Service Advisory

ZT SERIES

W-135

Subject: **Bypass Rod (747-04217C)**

FIGURE 1.

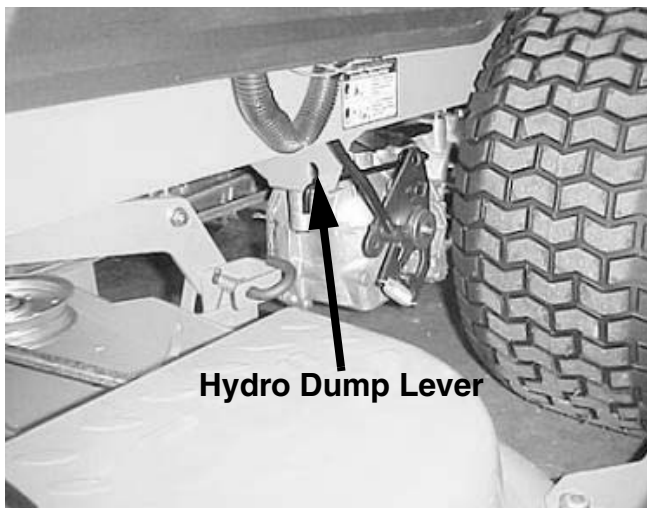
PURPOSE: To bring attention to the hydro bypass rod not being able to be released / activated when the cutting deck is in the highest position.

Lower the cutting deck to the lowest position. Locate the hydro bypass rod located on the left side of the unit, the dump rod faces the front of the unit with the lever facing down as shown in Figure 1.

Install the new 747-04217C bypass rod. Install a new cotter pin to secure the bypass rod to the bypass arm on the hydro transmission. Repeat the same process for the right hand side bypass rod. **NOTE:** The bypass rod on the right hand side will have the lever facing up.

FIGURE 2.

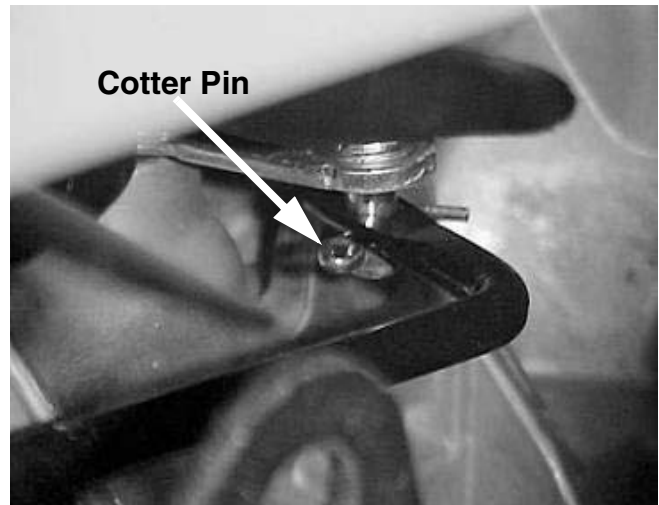
Remove the cotter pin that secures the hydro dump lever to the bypass arm on the hydro transmission. Shown in Figure 2. Pull the hydro dump lever out the front off the keyhole slot in the frame bracket.
